MDS Building – 5th Floor Renovation

ADDENDUM #3

#### **Addendum Number Three**

### **SHA.UKY2205**

MULTI - FLOOR ELECTRICAL PLAN
MDS FIFTH FLOOR RENOVATION
UNIVERSITY OF KENTUCKY
LEXINGTON, KENTUCKY

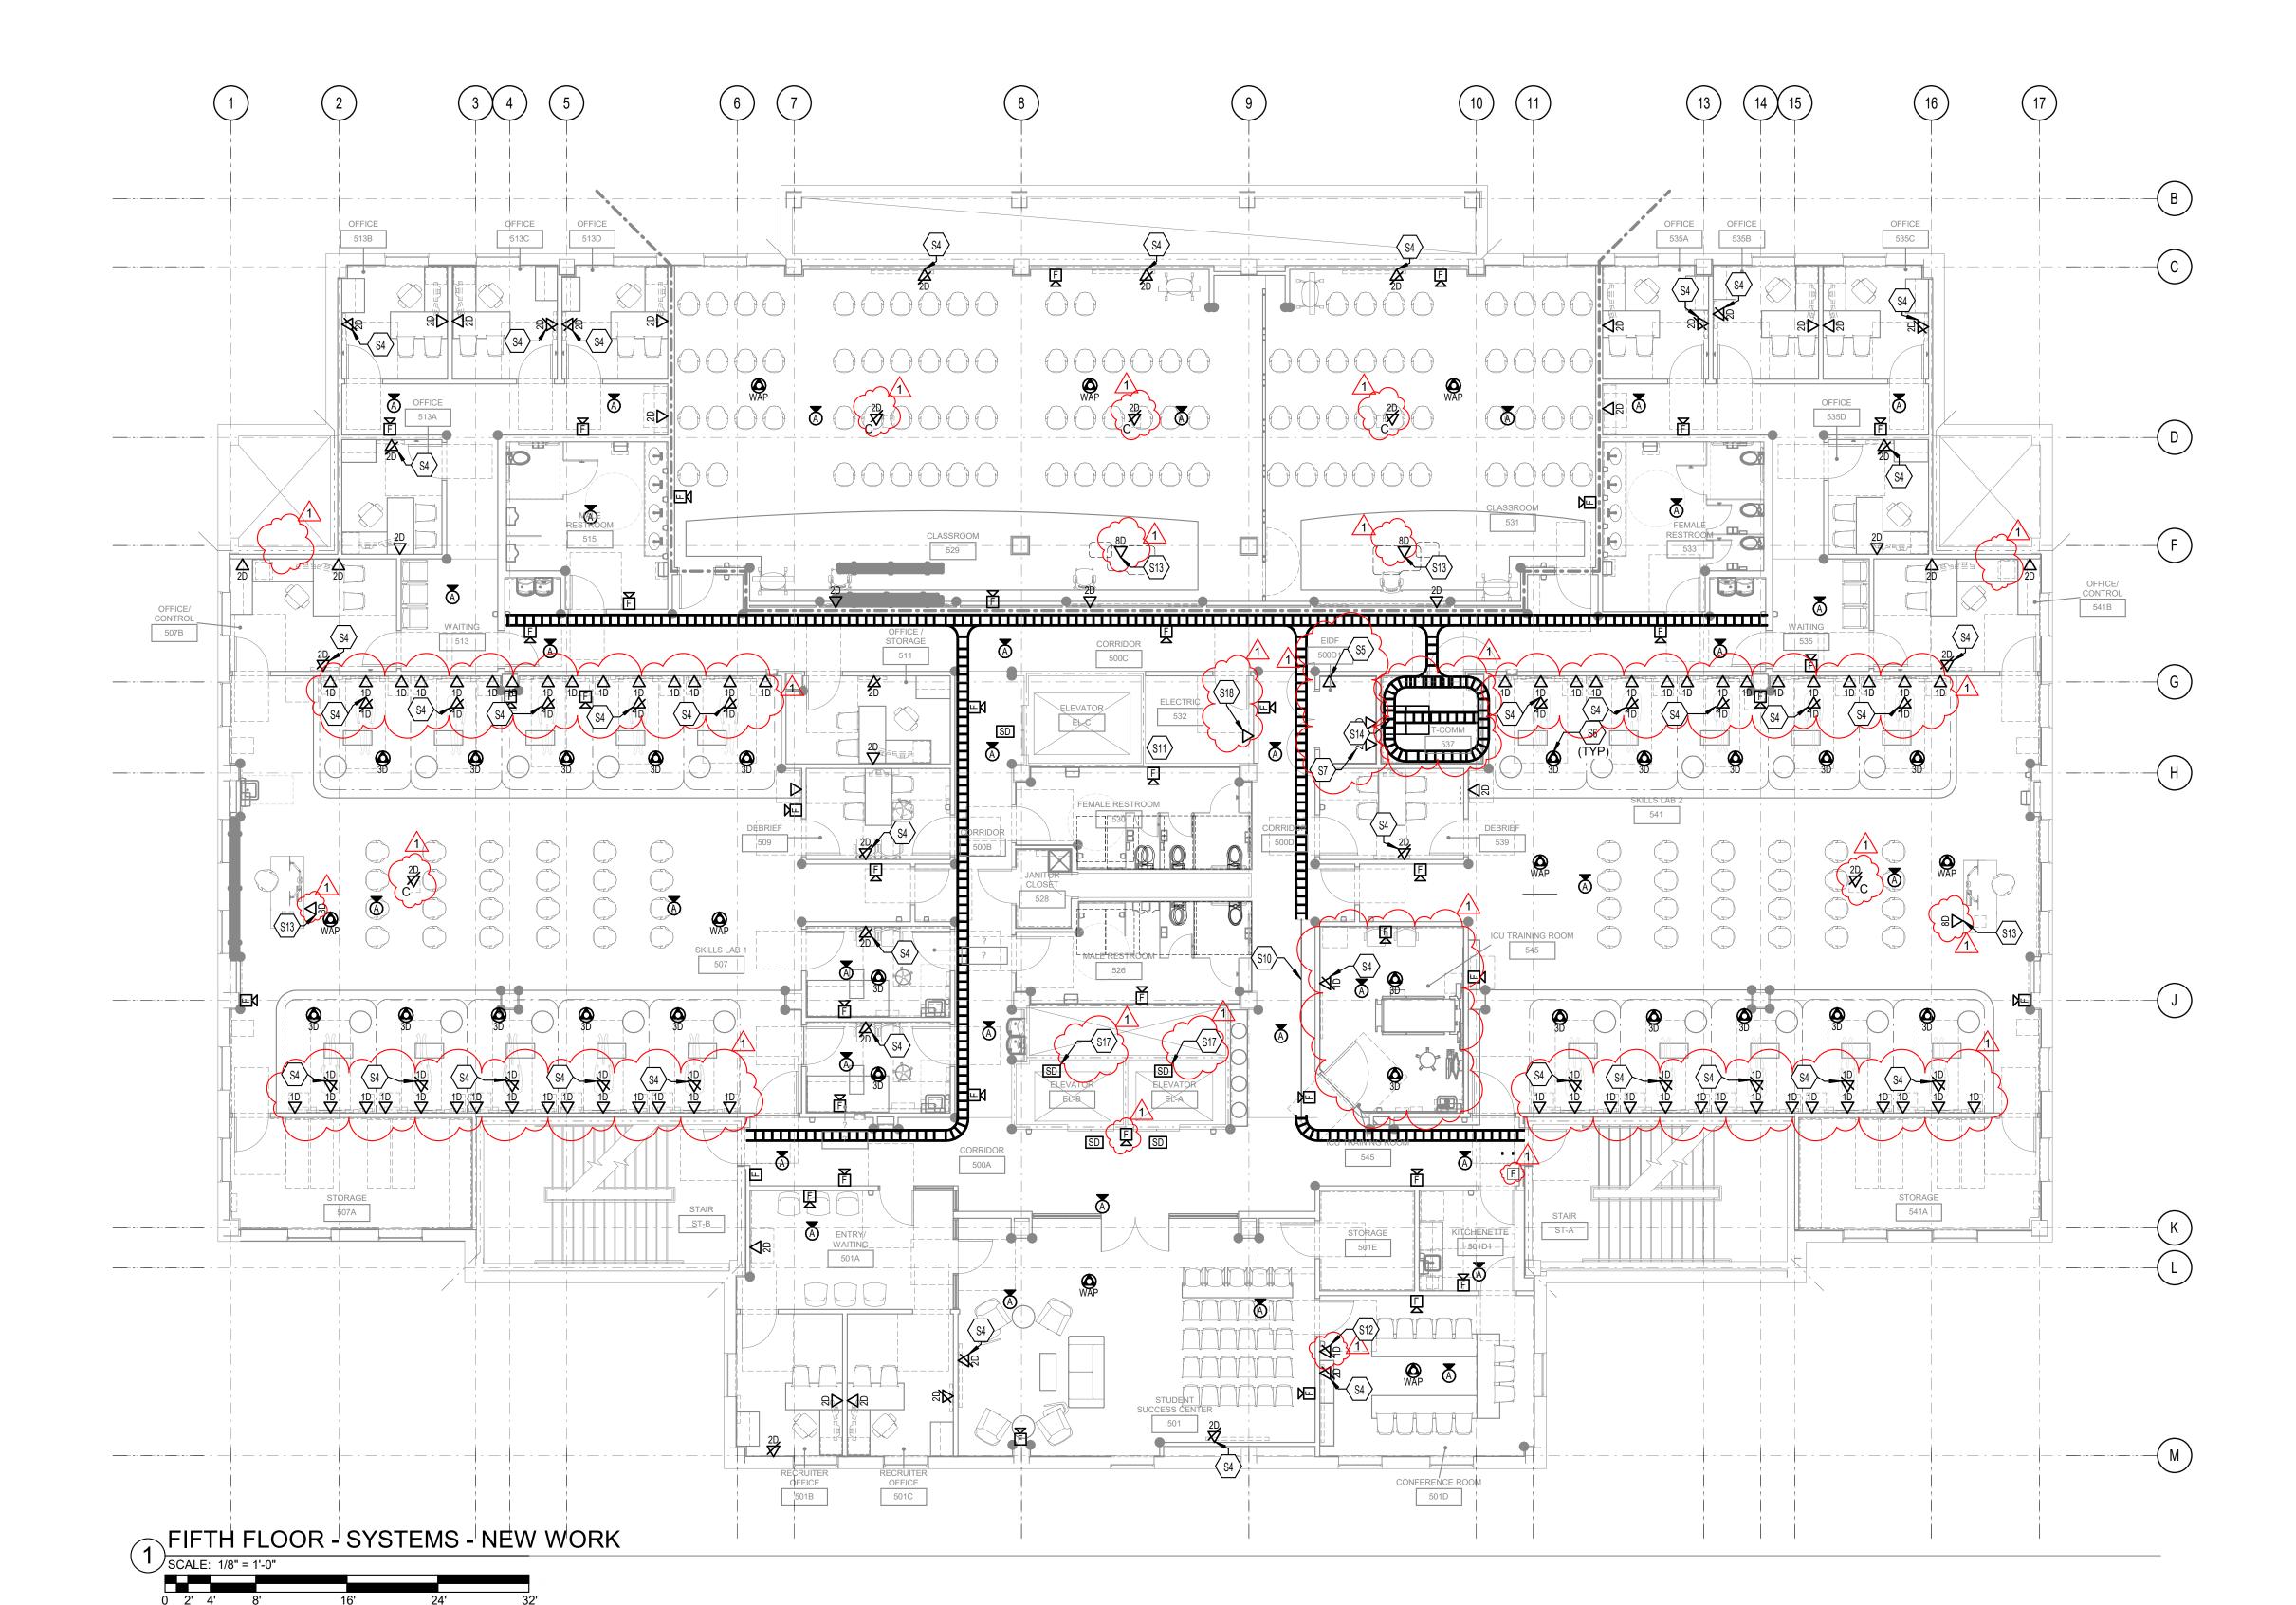
**A. Clarification:** Added location of electrical feeders going through floor to 1st floor.

#### **DEVICE MOUNTING DETAIL - KEY NOTES:**

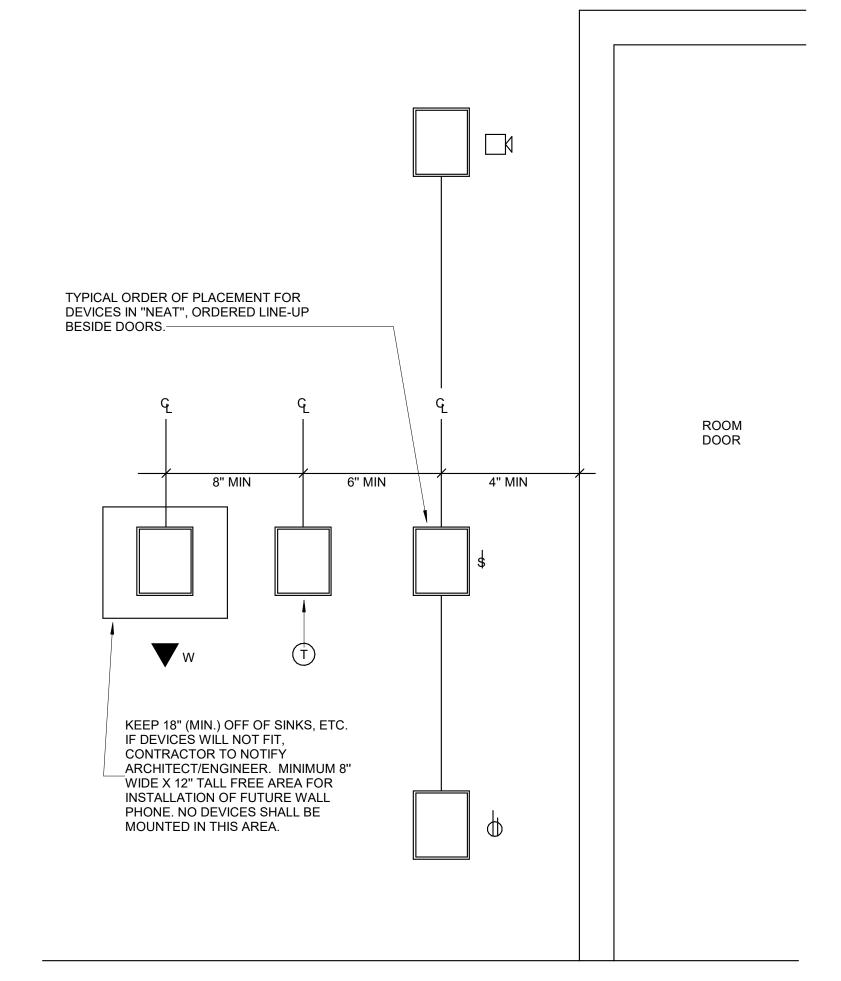
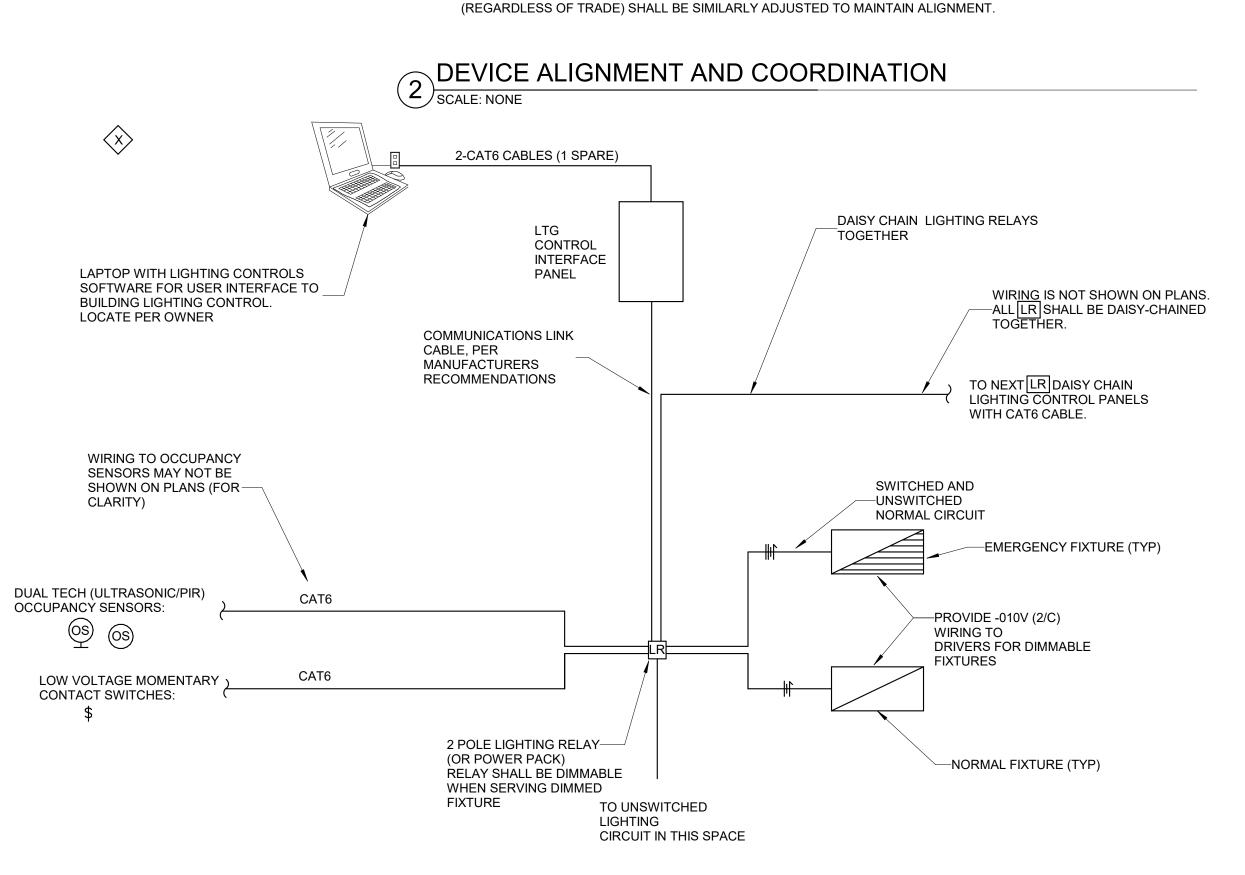
**A. Clarification:** Added detail for wall device mounting heights and coordination.

# 2 LIGHTING CONTROL SEQUENCE SCALE: NONE

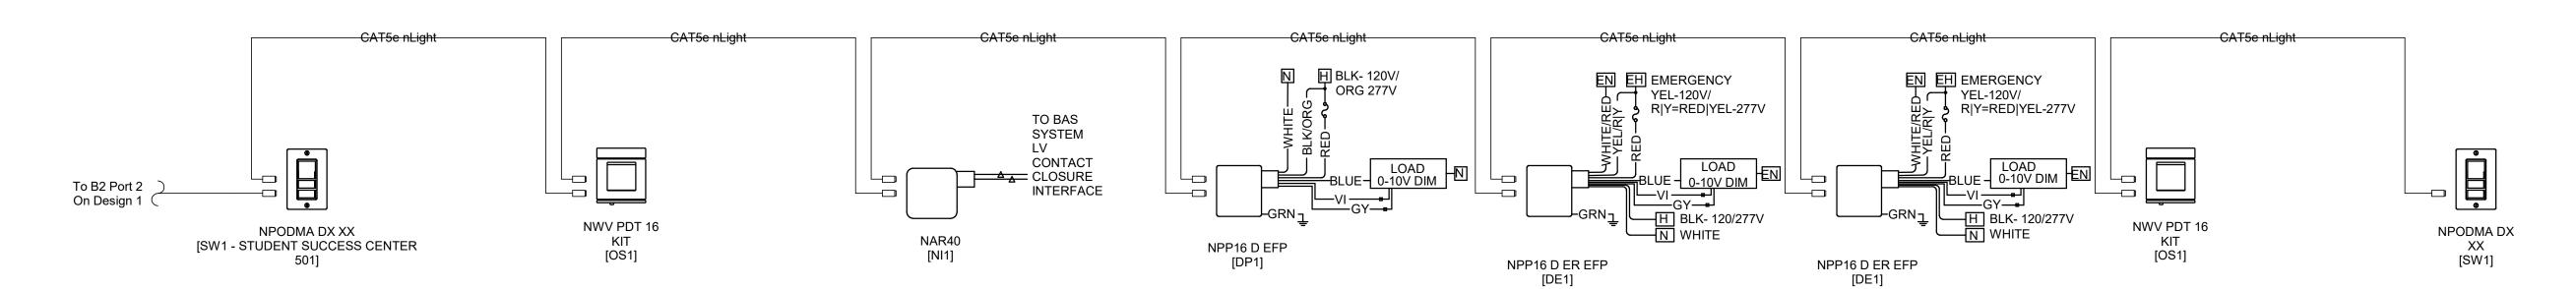
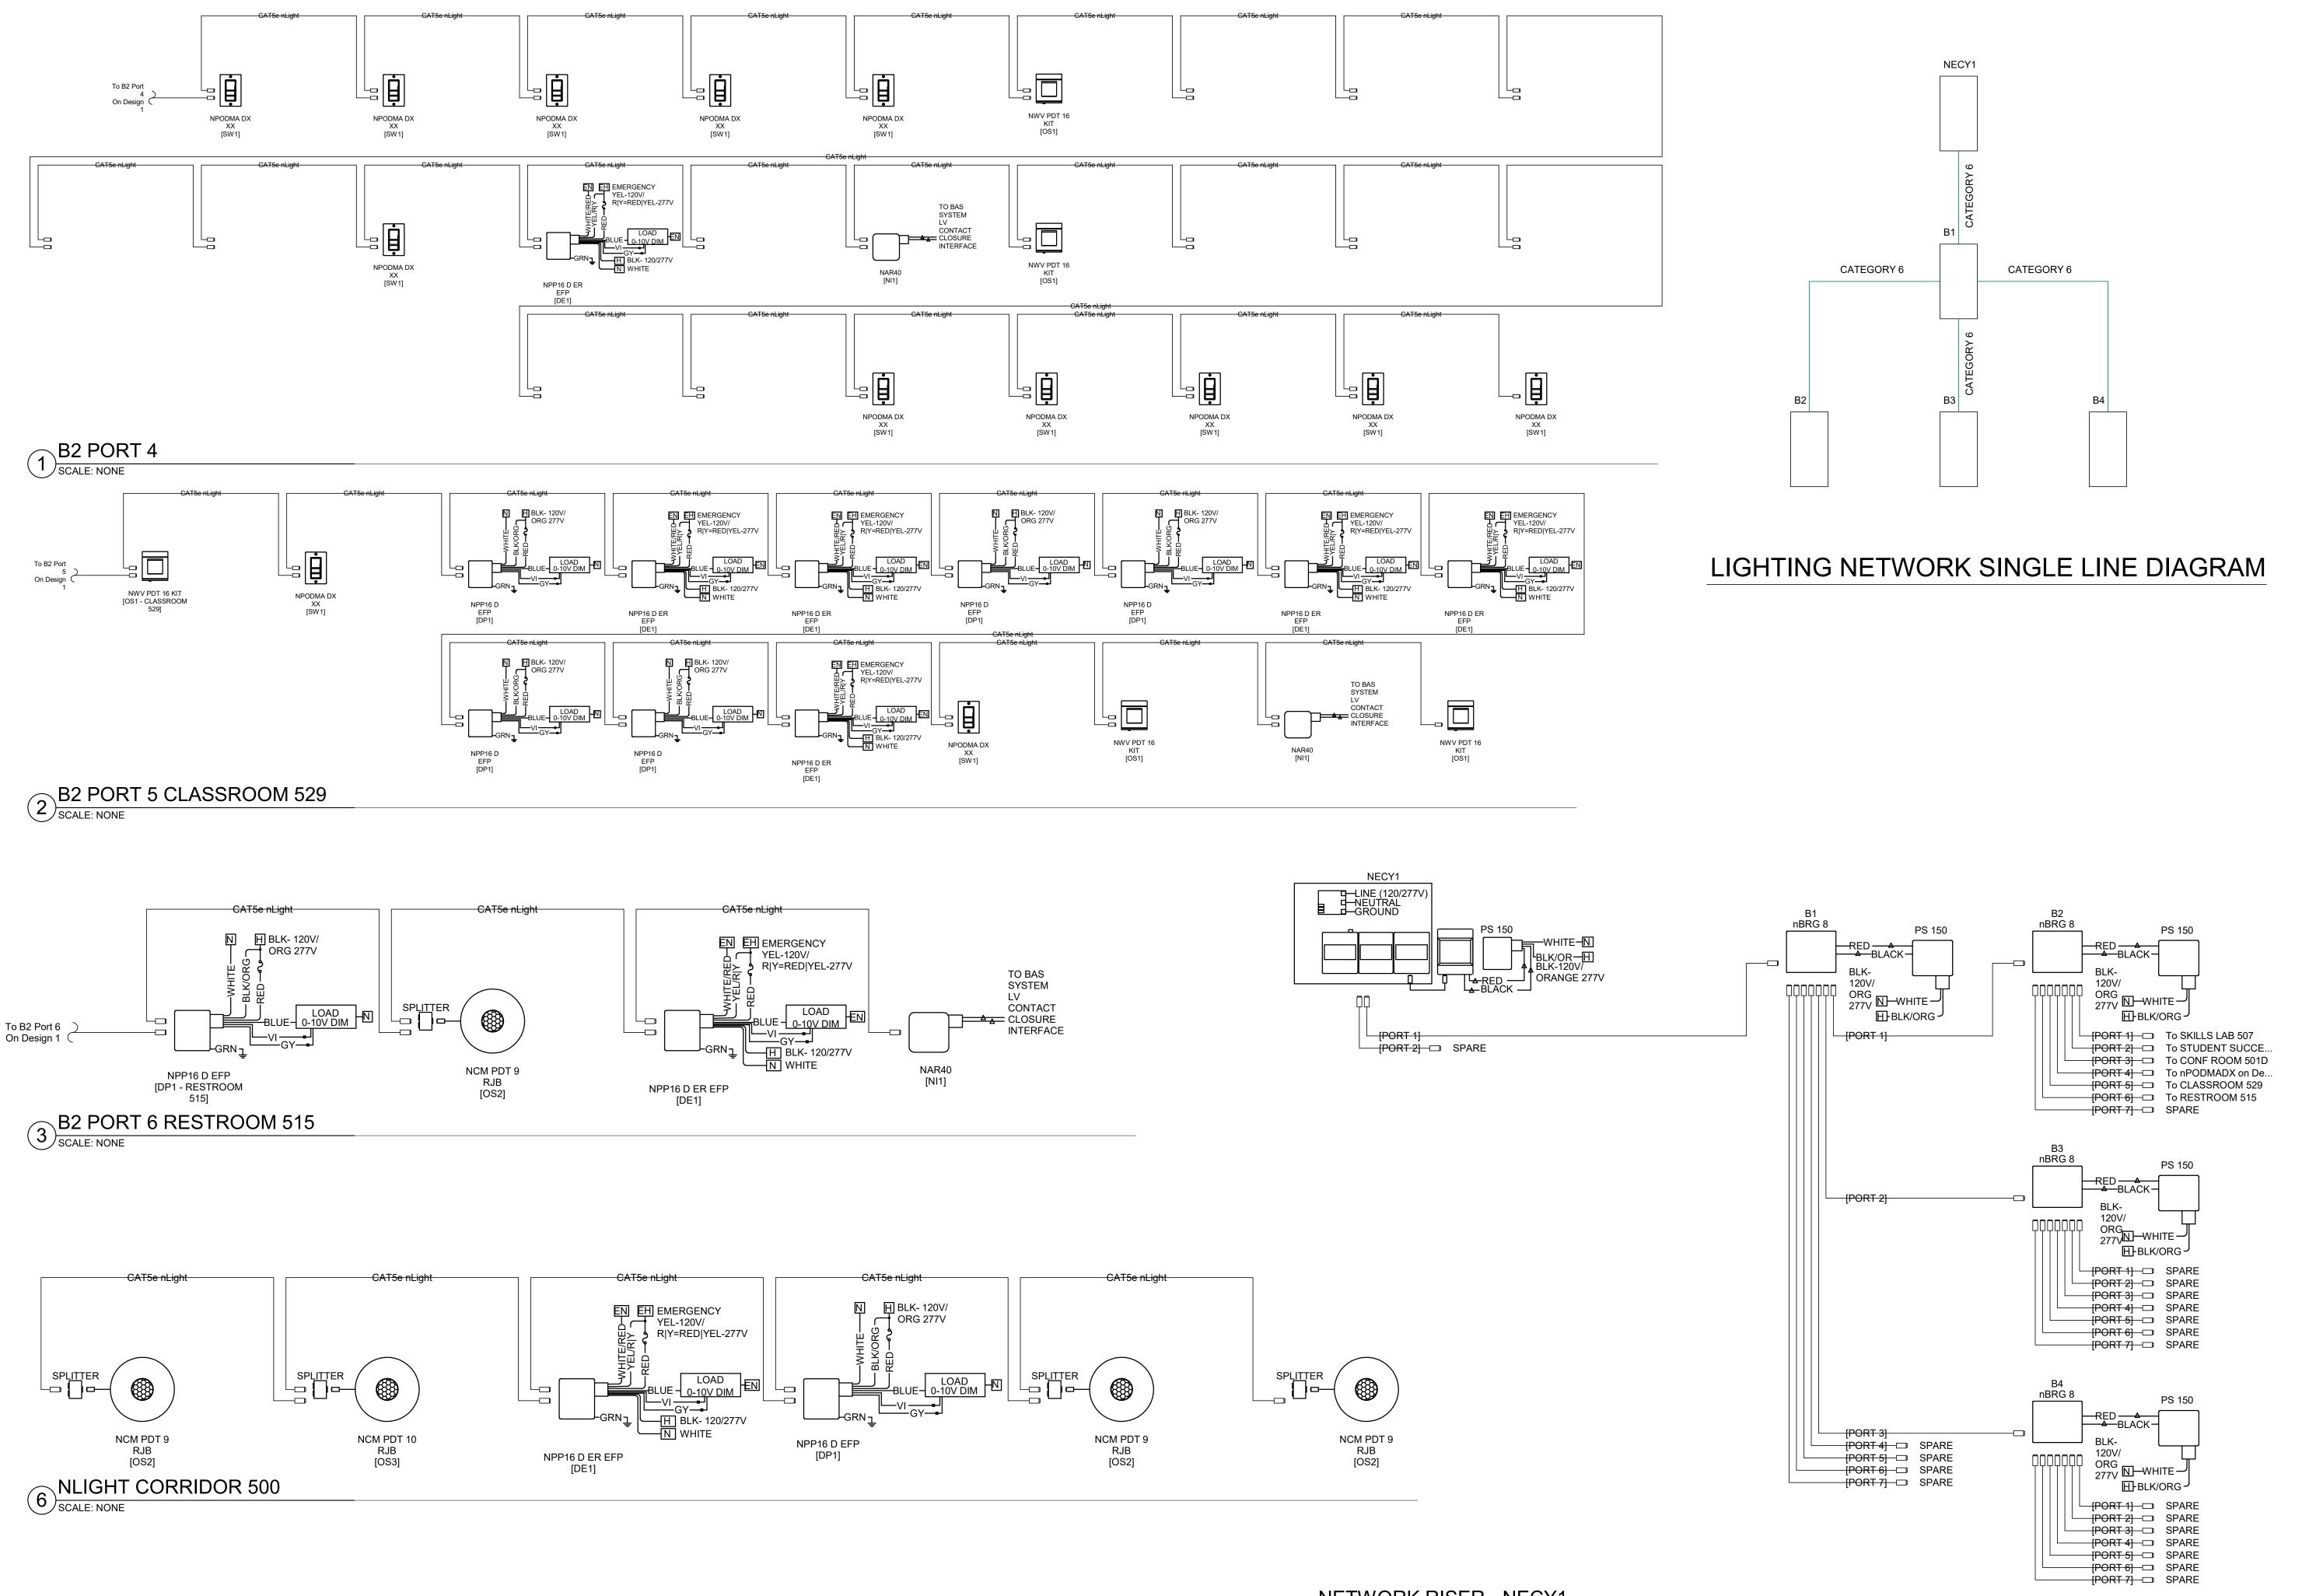
**A. Clarification:** Added sheet for lighting control diagrams.
